DISPUTE REVIEW BOARD RECOMMENDATION

**FINANCIAL PROJECT ID. 231919-3-52-01 & 231920-2-52-01
INTERSTATE 95 (SR-9)
PALM BEACH COUNTY**

RE; I-95 (SR-9) Reconstruction from North Of SR-80 to North of Palm Beach Lakes Boulevard
Palm Beach County

Subject: Dispute over Entitlement to Compensation for Required Adjustments to Reinforced Erath Retaining Wall.

Figure 1
Figure 3

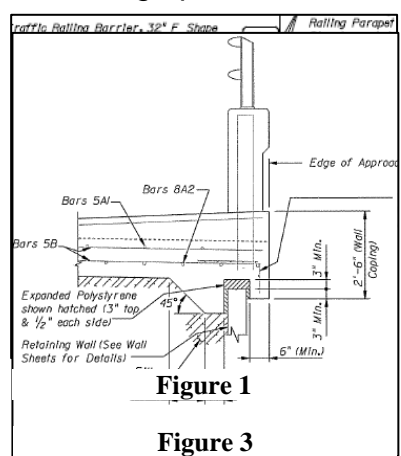
(Exhibit D), all of which show that the approach slab has a raised sidewalk. HCC also claims that the section through the approach slab with retaining wall as shown on A-12 does not correctly detail the situation in this case with a raised sidewalk (Figure 1). Sheet A-12 is FDOT Standard Index S-900, and it includes Section B-B "Approach Slab with Raised Sidewalk" (Figure 2) which details of coping would be the raised sidewalk. Standard Index was RSH only to add the Quantities (original S-

2 of 2 is attached as Exhibit E for comparison). In an effort to assist with the resolution of this issue, RSH issued a detail showing how the section thru the approach slab and retaining wall would look had it been detailed with the raised sidewalk (Figure 3 & Exhibit F).

Figure 2

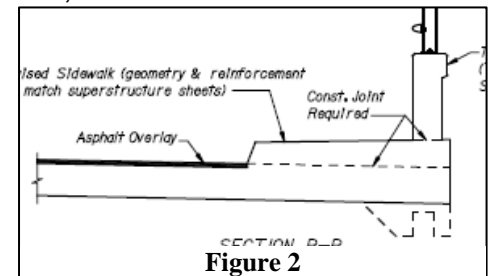
"Sidewalk" how the top affected by This FDOT modified by Estimated 900 Sheet
